NEW CONSTRUCTION STAGE PROPERTY INSPECTION REPORT AS4349.0-2007

Type of Inspection Completed	Practical Completion Inspection
Have Architectural and/or Structural Engineering Plans been provided for this inspection:	Yes

Location: Slab edge to entire perimeter of home.

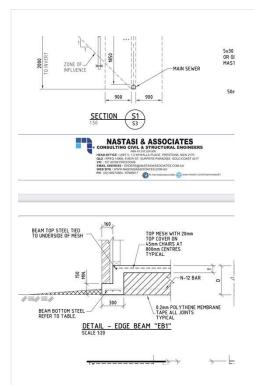
Details: Numerous spots have been excavated to expose the slab edge.

No vapour barrier visible to all locations.

Vapour barrier is required to prevent moisture penetration to the slab perimeters as it does for the underside.

VAPOUR BARRIER must be placed beneath the slab so that the bottom surface of the slab is entirely underlaid and extends under edge beams to finish at ground level. Refer figure 3.2.2.3 in NCC or figure 4.2.8 in NCC 2022

Recommendation: Entire slab edge will need to be exposed and excavated and be treated with a suitable membrane recommended by the acting engineers.

Location: Slab edge perimeters.

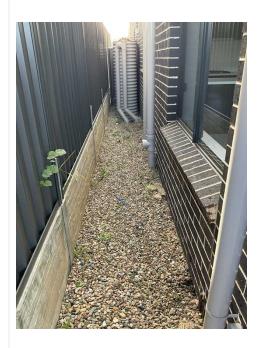
Details: More examples of no vapour barrier.

Recommendation: As per previous.

Location: Rear side of property.

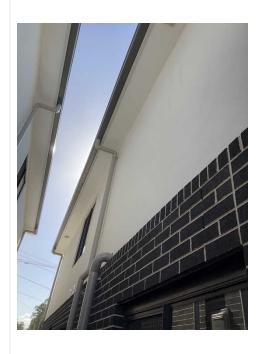
Details: Articulation joint is incomplete.

VERTICAL articulated joints 3.3.5.13 not required for class A or S sites.

Articulation joints between masonry elements must have a width not less than 10mm.

Recommendation: Articulation joint to be completed and cut in.

Location: Front eaves and wall junction.

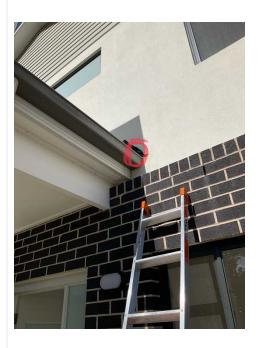
Details: Gaps inbetween cladding and eaves.

All exterior surrounding should be sealed with no gaps.

Recommendation: Builder to caulk or install timber trims etc.

Location: Ground floor bathroom and laundry.

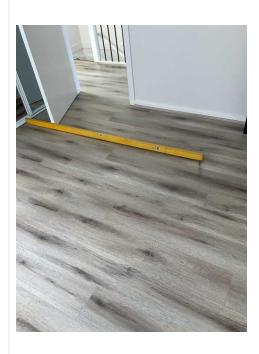
Details: Shower door requiring a door stop for safety reasons.

Door can hit Toilet pan and shatter.

This is safety issue and concern.

Recommendation: Builder to address door issue.

Location: Kitchen doors above range hood.

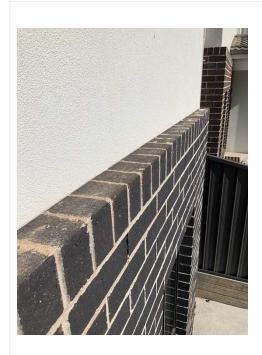
Details: No push catches. Was very difficult to open.

Recommendation: Push catches to be added.

$\textbf{Location:} \ \textbf{Masonry at cladding and brick junction}.$

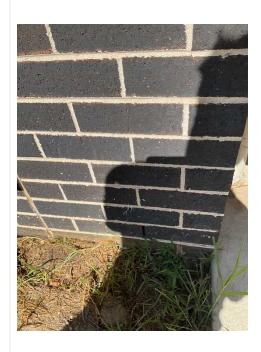
Details: Mortar stains.

Requires cleaning.

Recommendation: Builder to clean all bricks of paint and

mortar stains to exterior surrounds.
